Product/Process Change Notification

Initiation Date		Notification No.	20220429
Implementation Date		Initiator's Name	Johanns Ocaba
Beginning Date Code of Implemented Change

Due to shortage of current Nut (Black Zinc Coated), Knowles Electronics has qualified alternate Nut (Blue Zinc Coated) for FB Microphone Assemblies. Parts meets specification. There is no change in fit, and functions. But there is a notable difference in the nut color.

MATERIAL PHOTOS

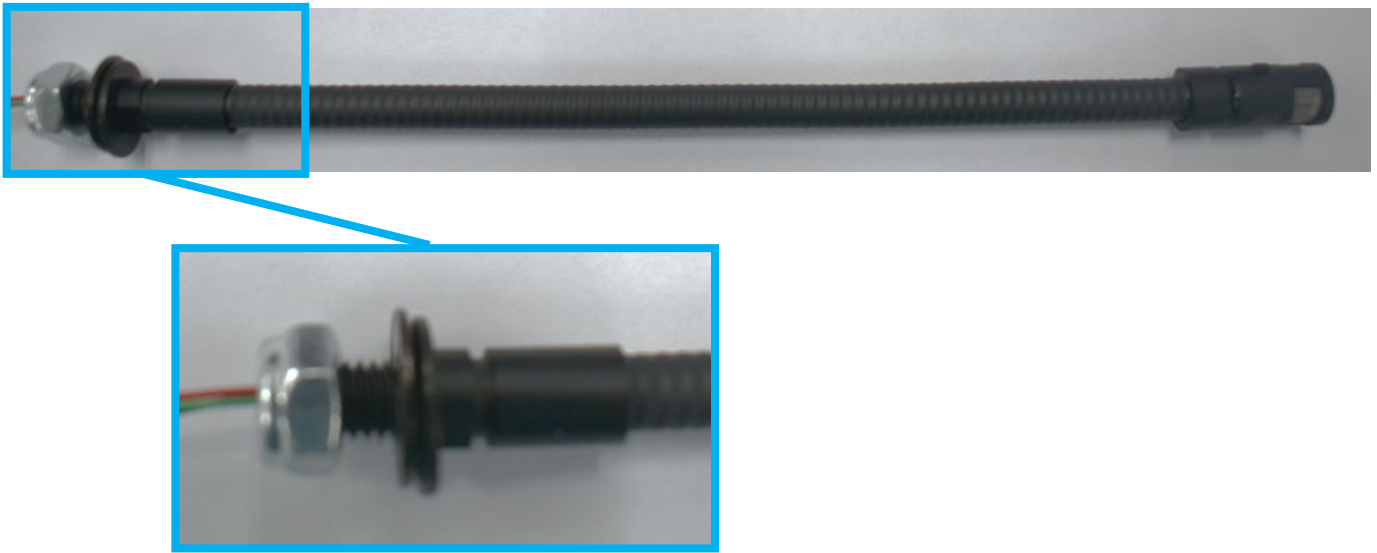
- Notable difference in the nut color, current nut is black with blue nylon lock, while new material is Blue Zinc (Silver colored)
